6.6 3/339 WILLIAMSTOWN ROAD, PORT MELBOURNE

**LOCATION/ADDRESS:** 3/339 WILLIAMSTOWN ROAD, PORT MELBOURNE  
**EXECUTIVE MEMBER:** LILI ROSIC, GENERAL MANAGER, CITY STRATEGY AND SUSTAINABLE DEVELOPMENT  
**PREPARED BY:** BRAD FOLETTA, SENIOR URBAN PLANNER

**APPLICATION NO:** Council Reference: 1060/2016/A

Figure 3: Section of Plan SK100 (Ground Floor Plan) – Original applications gas and water meter location.

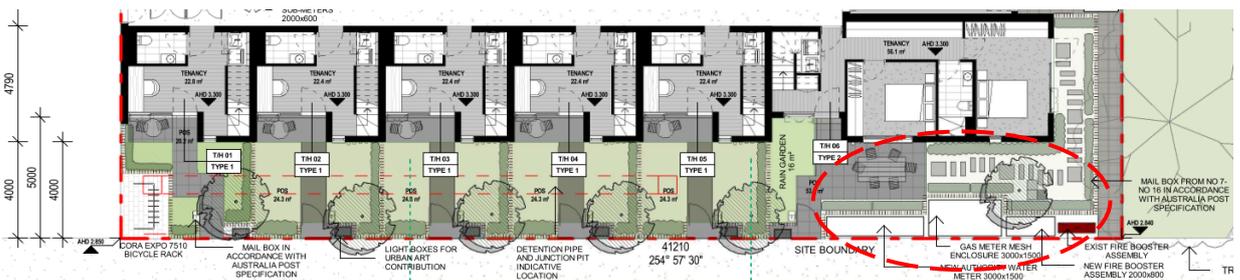
5.5 The below plan segment formed part of those current at the time of the original decision and show location of the service cabinets directly prior to Condition 1(f) being incorporated on the permit.

Internal Department / Referral Officer	Referral Comments (summarised)
Urban Design	<ul style="list-style-type: none"> <li>• From the plans submitted it is unclear as to how the site services are now incorporated into the architectural and landscaping to minimise visibility. The plans show a thin green line outlined around the fire booster cupboard and the section renderings do not correspond with any landscaping resolution - only materials, which will provide little benefit in minimising the visibility from the public realm.</li> <li>• In saying that the location of the mailbox and bike parking in this location is supported and is towards the right direction to improve this amenity within the current constraints.</li> <li>• It must be noted that the location of these services should be investigated at an early stage which allows the proposal to respond to and integrate these into the overall design of the building rather than result in what will result in an attempt to disguise an afterthought design approach.</li> <li>• One suggestion could be that they extend the line of planting to Williamstown Rd to continue the landscape screen to the reserve</li> </ul> <p><b>Planning Officer Comment:</b></p> <ul style="list-style-type: none"> <li>• The original plans proposed a 9.4 metre long continual stretch of service cupboards (Gas, water and Fire) directly on the south-east corner site boundary presenting to Williamstown Road. The revised design reduces this down to two smaller service cupboards of only 1.7 metres in width each broken up by the visitor bike parking area, a vast reduction in built form presented to this interface.</li> </ul>

|  | <ul style="list-style-type: none"><li>• The modified layout of the fire booster and water meters whilst not the preferred option will still facilitate a built form outcome for the service cabinets and associated bicycle parking that will soften their impact to the public realm and help integrate the forms into the boundary fencing and landscape treatments presented to J. L. Murphy Reserve and Williamstown Road, given the option of relocating the services is no longer viable.</li><li>• The suggested increase in the extend of planting along the common pathway in front of the water meter cupboards facing JL Murphy Reserve to facilitate a continued landscape screen to the reserve could not be implemented as it would prevent access to the service cupboards.</li></ul> |

3.1.1 That condition 1(f) of the permit be modified to state: *“Incorporation of the site services into the architectural and landscape design of the development generally in accordance with Plan TP100, revision A, received by Council on 9 September 2018, so as to minimise visibility from the public realm.”*
